Subject: **Response to Portion of NRC RAI Letter No. 290 Related to ESBWR Design Certification Application - DCD Tier 2 Section 3.7 – Seismic Design; RAI Number 3.7-63 S02 Revision 1**

**Response to NRC RAI Letter No. 290  
Related to ESBWR Design Certification Application<sup>1</sup>**

**DCD Tier 2 Section 3.7 – Seismic Design**

**RAI Number 3.7-63 S02 (Revision 1)**

**Figure 3.7-63(9) FRS (Effect of Structure-Structure Interaction) – CB Top X**

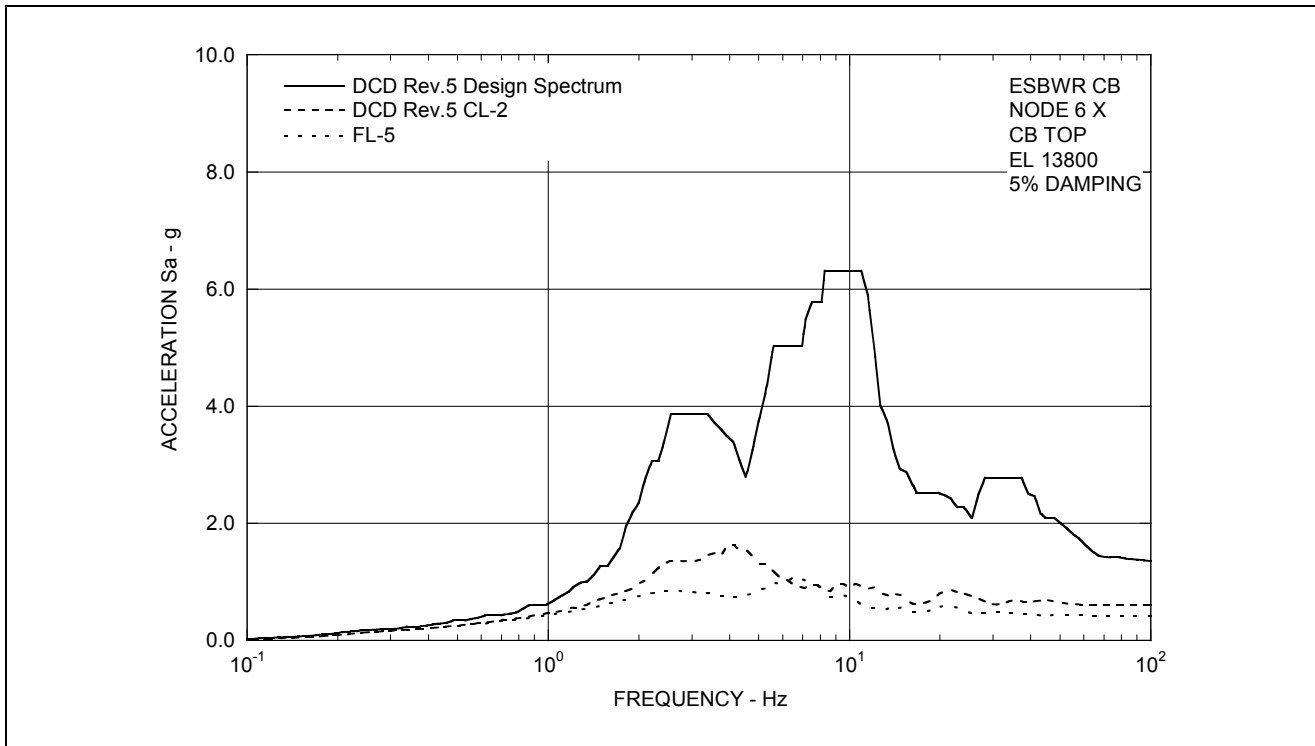
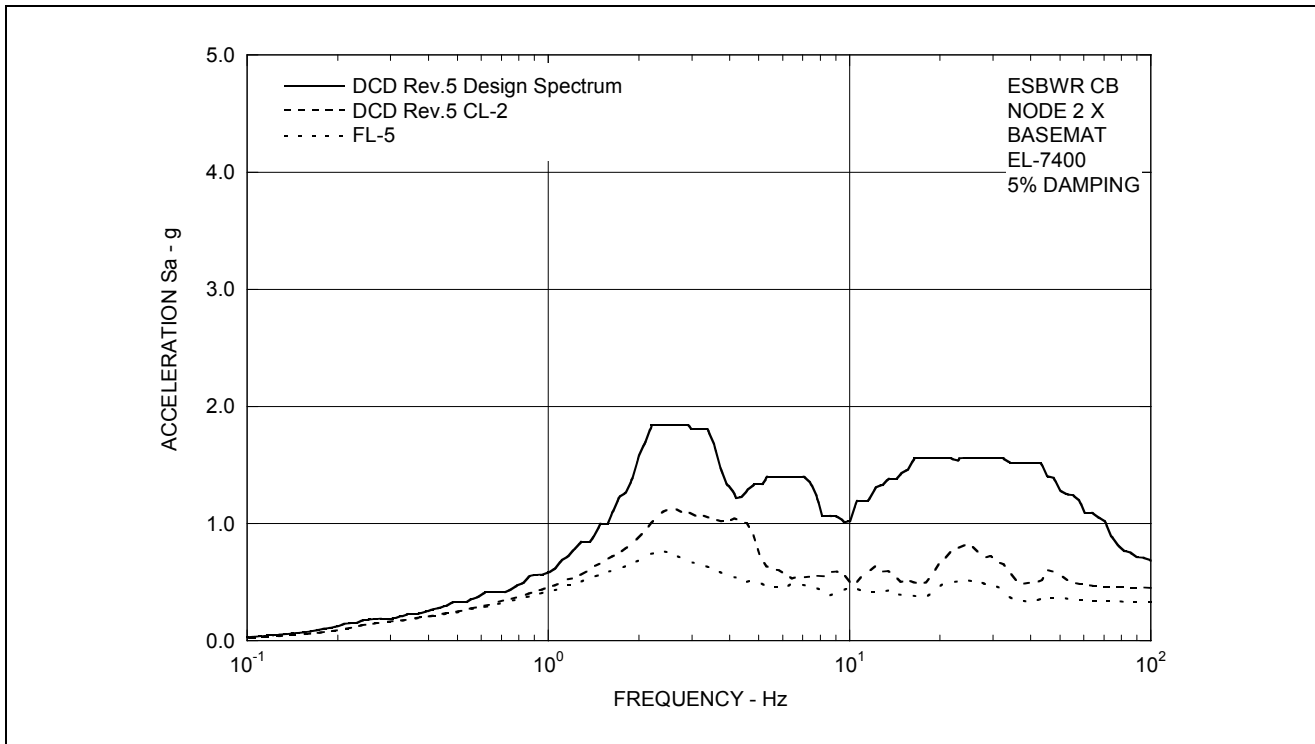
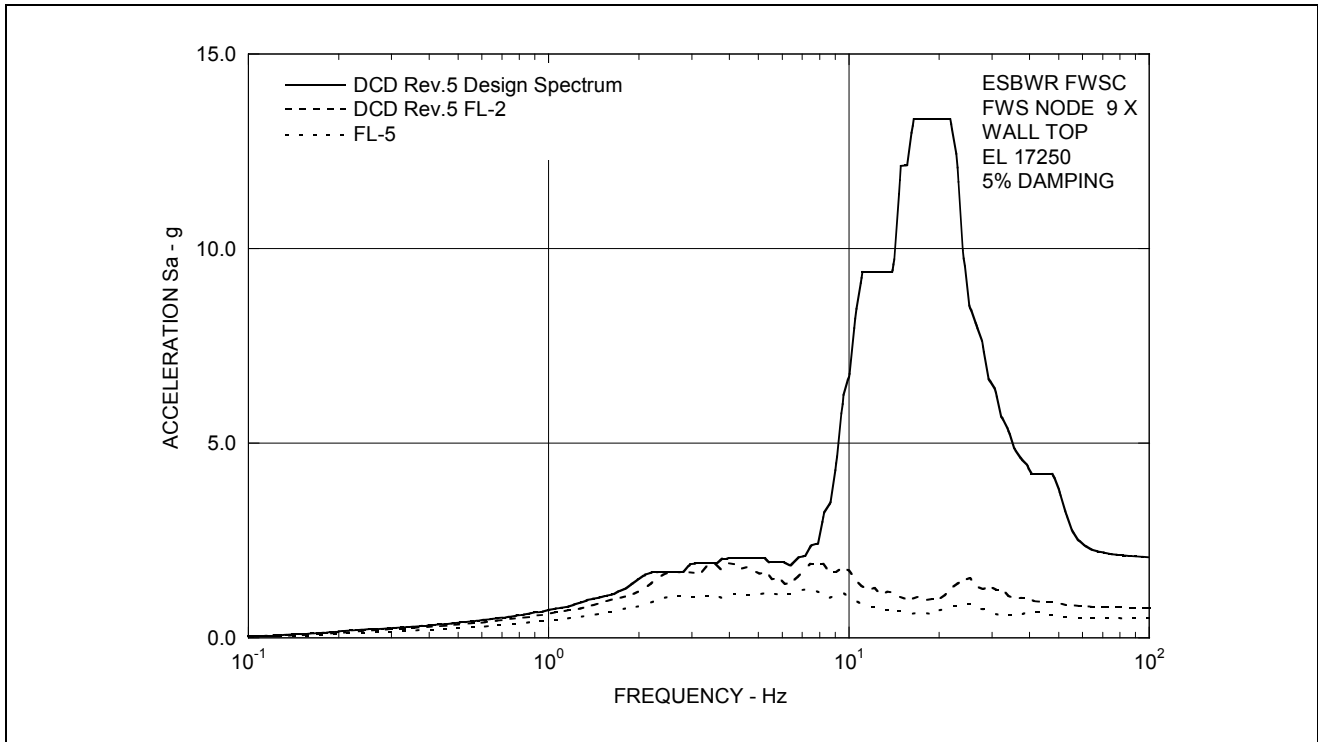
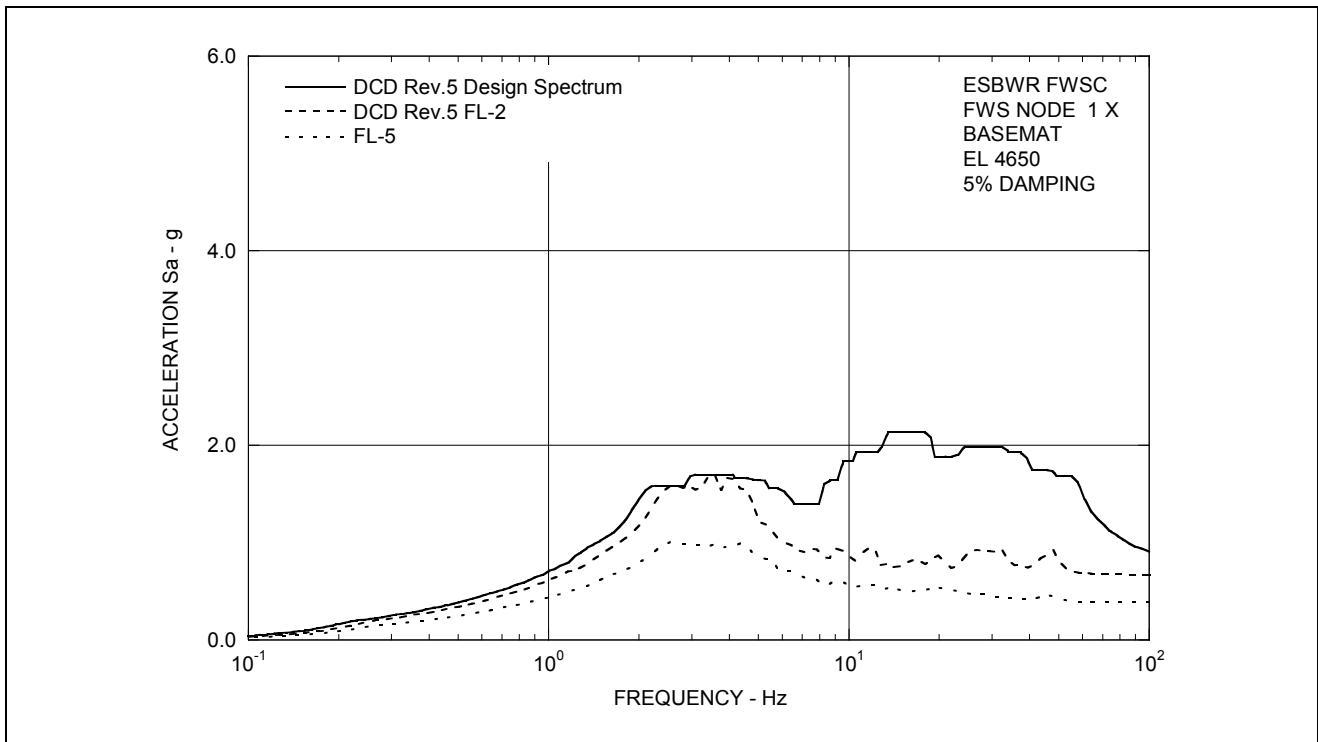
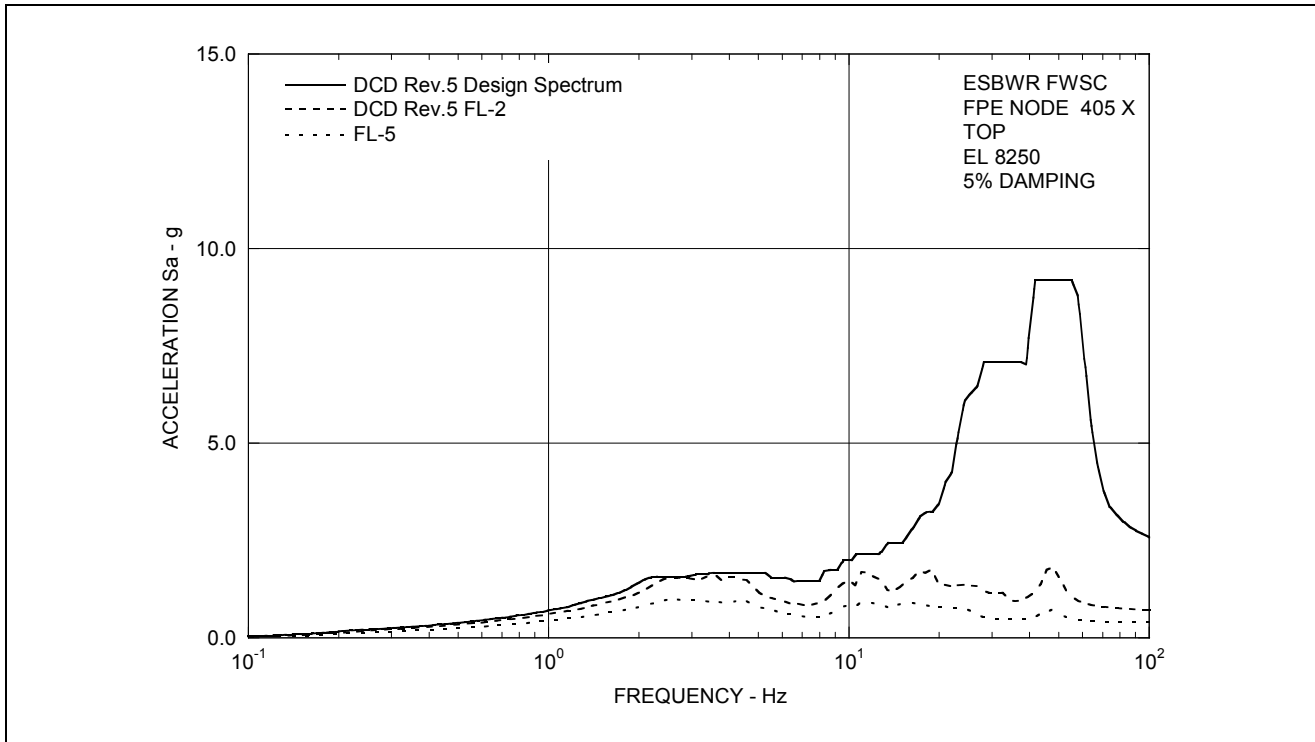
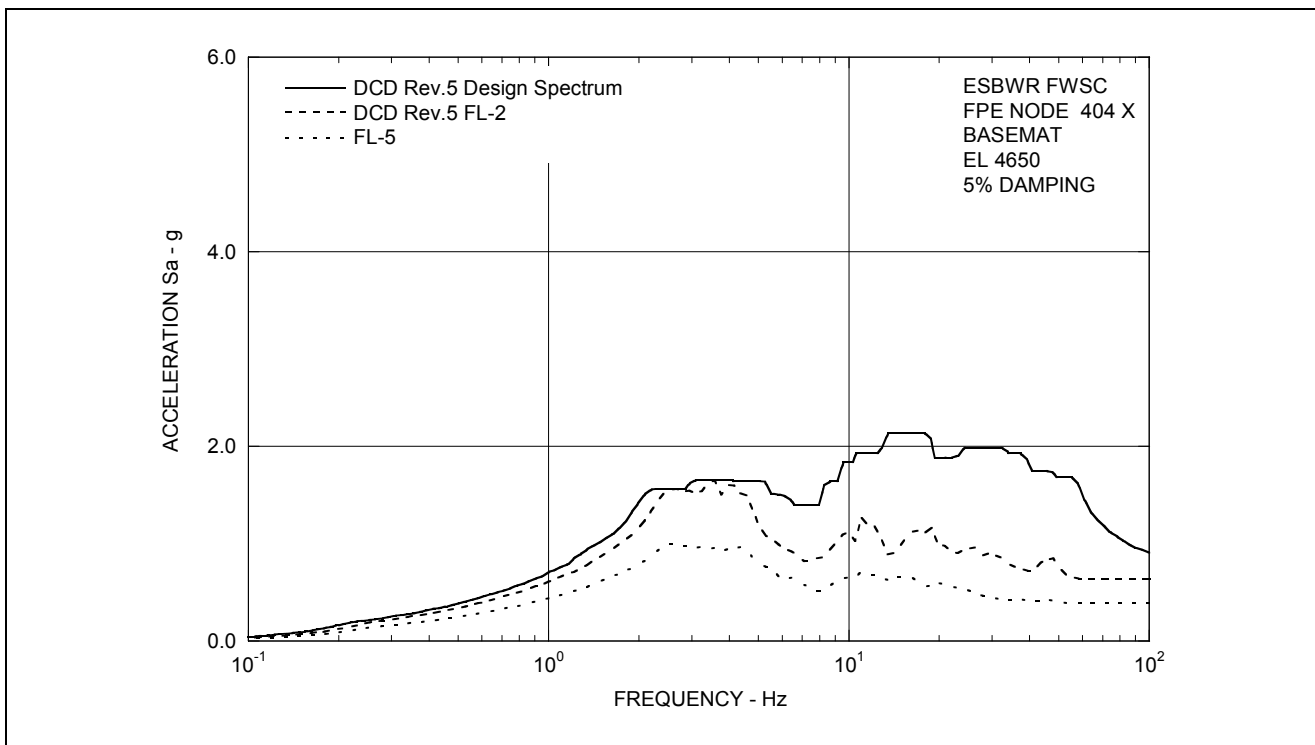
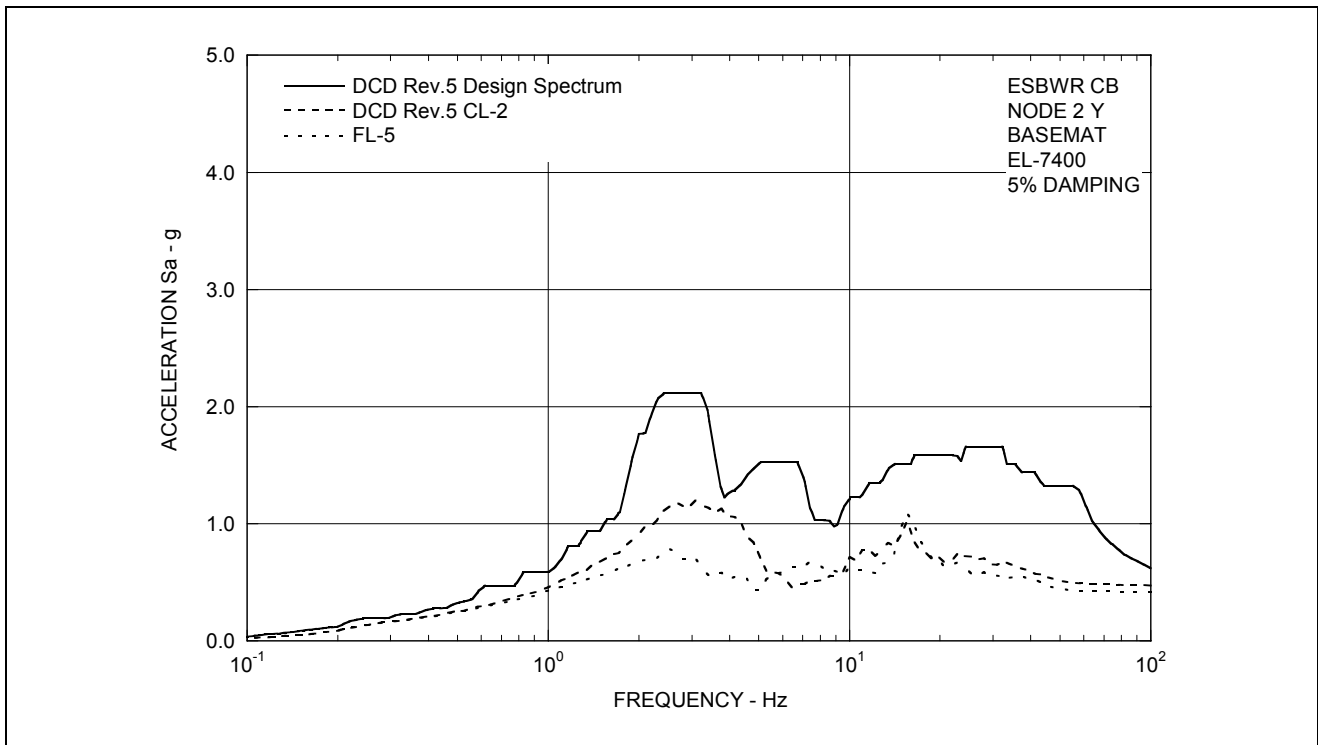
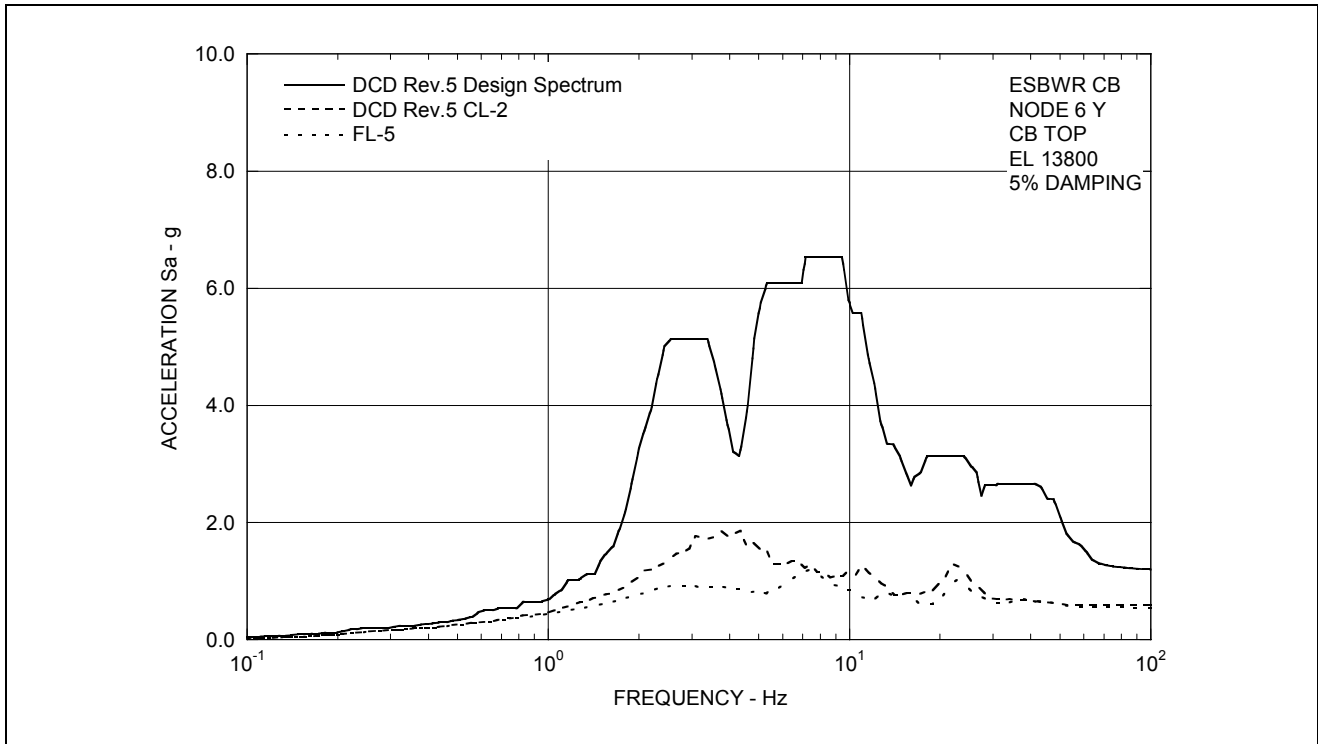
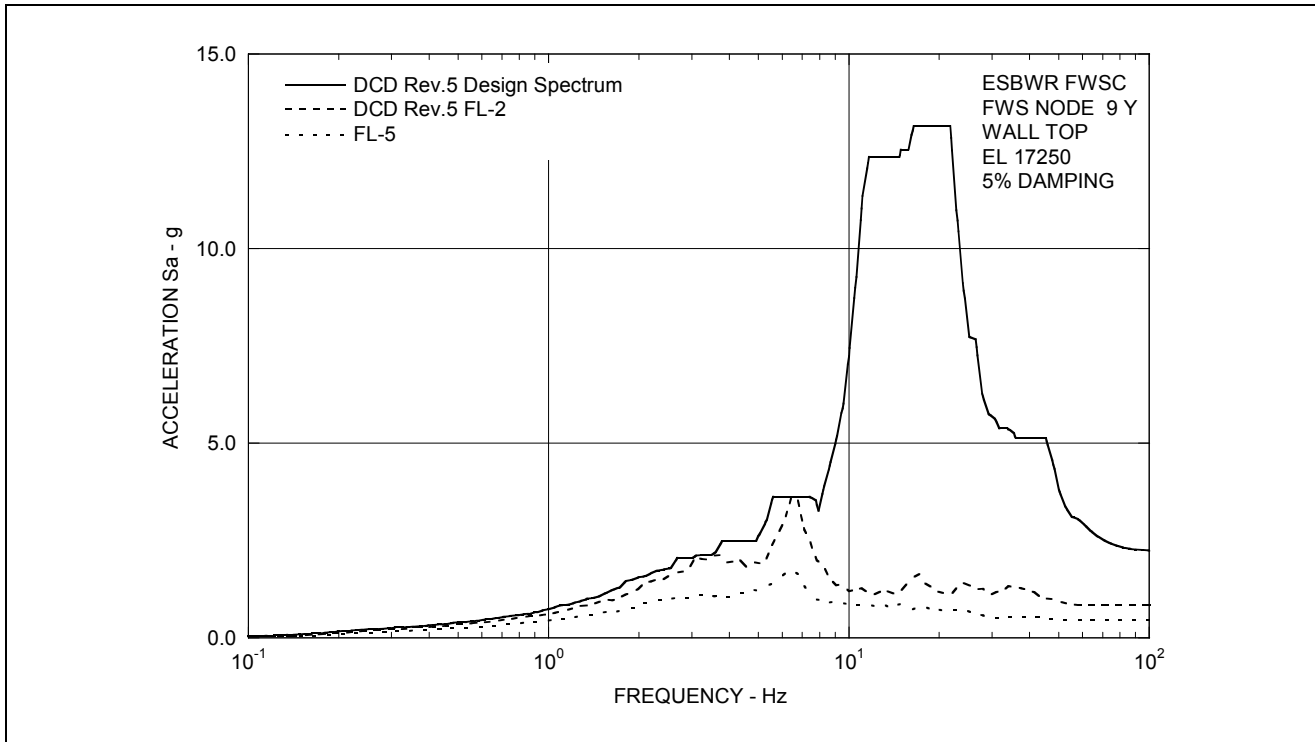
*During a teleconference on 12/10/2008 related to RAI 3.7-63 S01, the staff discussed with GEH how the potential for structure-soil-structure interaction was addressed in its evaluation of the FWSC. GEH indicated that it had not conducted any specific analysis due to the appreciable distance between the closest building (CB) and the FWSC. The staff considers that a quantitative evaluation of this potential effect is needed to address this issue. The following two approaches may be considered:*

Figures 3.7-63(9) through 3.7-63(26) show comparisons of floor response spectra (FRS) with the design envelope spectra at selected locations in the two structures. The FRS for the corresponding analysis Cases CL-2 and FL-2 without the structure-soil-structure interaction effect are also shown in the figures for comparison. It is confirmed from the results that the FRS with the structure-soil-structure interaction effect are bounded by the DCD Revision 5 design envelope spectra in all frequency ranges. Consequently, it can be concluded that 1.35 times CSDRS is a conservative design input motion to the FWSC and can be compared with the site-specific FIRS directly without considering structure-soil-structure interaction effects in COL applications. DCD
